Subject: FORT CALHOUN STATION – NRC SPECIAL INSPECTION REPORT
05000285/2013-012

Report: 05000285/2013-012

IR 05000285/2013-012; 01/28/2013 – 03/15/2013; Fort Calhoun Station; Special Inspection Report; IP 93812; Design Control and Corrective Action Violations.

Figure 1 - DWG 11405-S-312 "design" drawing

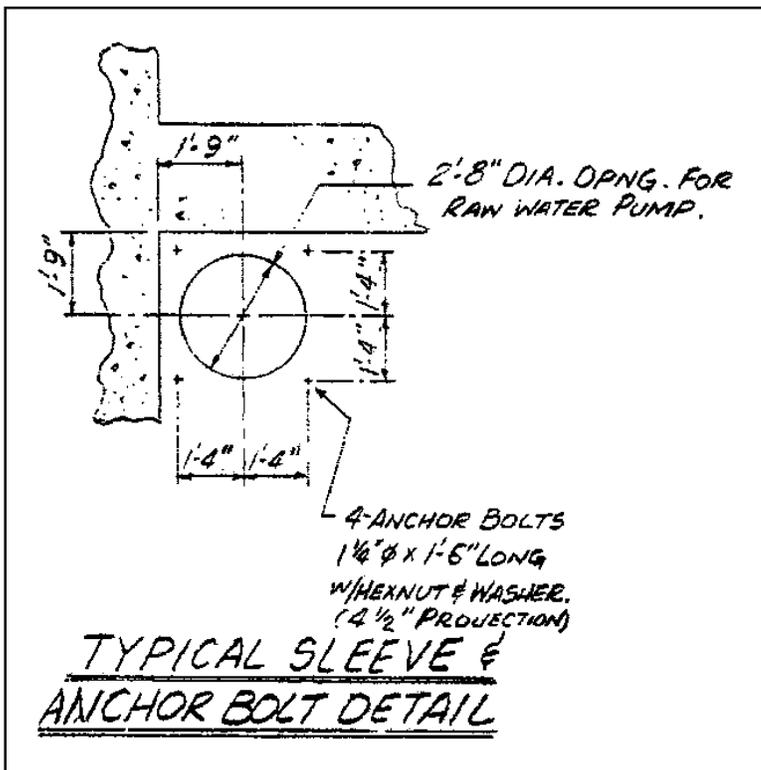
The design drawing 11405-S-312, as shown in Figure 1, did not contain sufficient information about the anchor bolt details or potential interferences.

1969	Fort Calhoun Station design drawing 11405-S-312 specifies 18 inch anchor bolts with hexnuts and washers for the raw water pumps are "Typical sleeve & anchor bolt detail." Engineering personnel interpreted this to mean a cast-in-place Type II (headed stud) anchor bolt.
July 1, 1969	"Shop" drawing number 154 specifies "ABL-154" markings for Type I (J-style) anchor bolts.
July 10, 1969	"Pour" drawing 7908-C specifies ABL-154 anchor bolts to secure the raw water pumps.
February 19, 1987	NRC issues Generic Letter 87-02 "Verification of Seismic Adequacy of Mechanical and Electrical Equipment in Operating Reactors (USI A-46)."

- October 28, 1993 OPPD SQUG engineers complete analysis for the raw water pump anchor bolts to respond to Generic Letter 87-02.
- The raw water pump anchor bolt SQUG calculation used design drawing 11405-S-312 as the only input, and incorrectly assumed the anchor bolts were Type II (headed stud).

Figure 2 - DWG 154 "shop" drawing

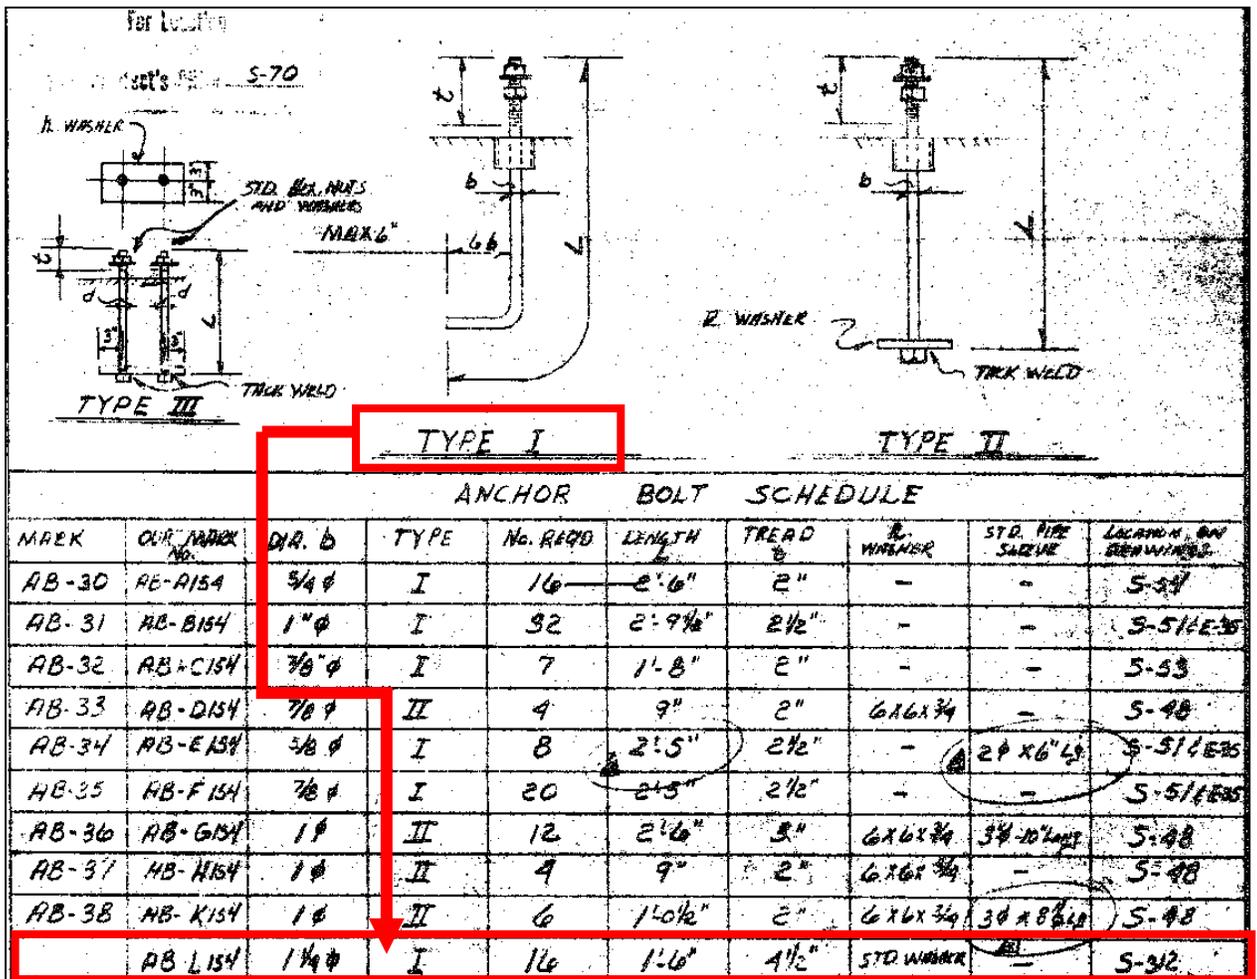
The engineer then referred to "shop" drawing Number 154 (Figure 2) and the construction "pour" Drawing 7908-C (Figure 3).

After reviewing the drawings, the system engineer did not expect that the shop drawing (Figure 2) would specify a Type I, or J-bolt. The J-bolt anchor was unexpected because station personnel assumed that the anchor bolts were Type II, or headed stud anchor bolts, based on design drawing (Figure 1). That incorrect assumption was used for the design basis of the anchor bolts. There was not an original design specification for the raw water pump anchors.

Figure 3 - DWG 7908-C "pour" drawing

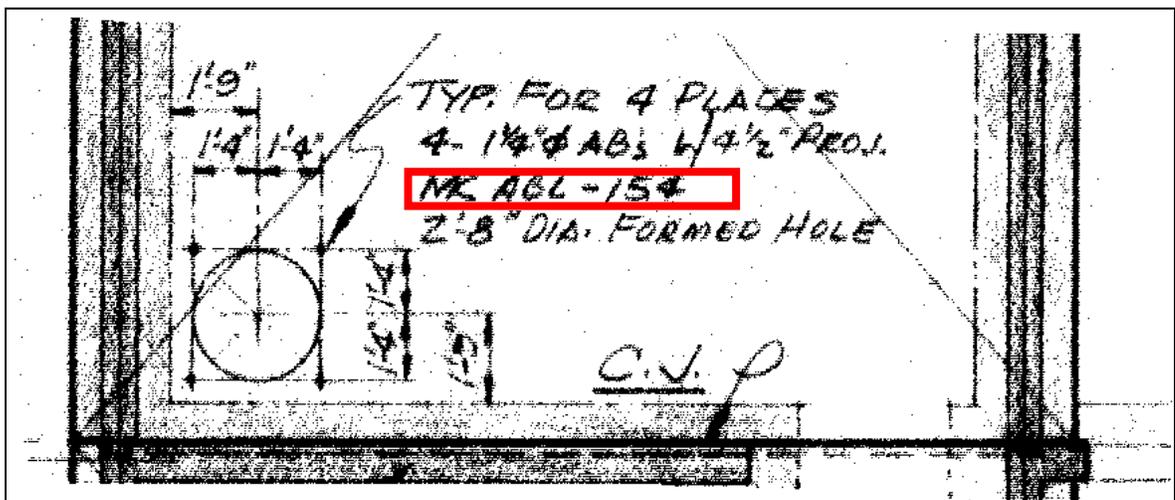
The design specification for the raw water pump motors is designated MK ABL-154 as noted in Figure 3. The corresponding anchor bolt data for an MK ABL-154 anchor bolt is found in the “schedule” shown in Figure 2. Clearly, the design specification for the anchor bolts was a Type I J-style anchor bolt.
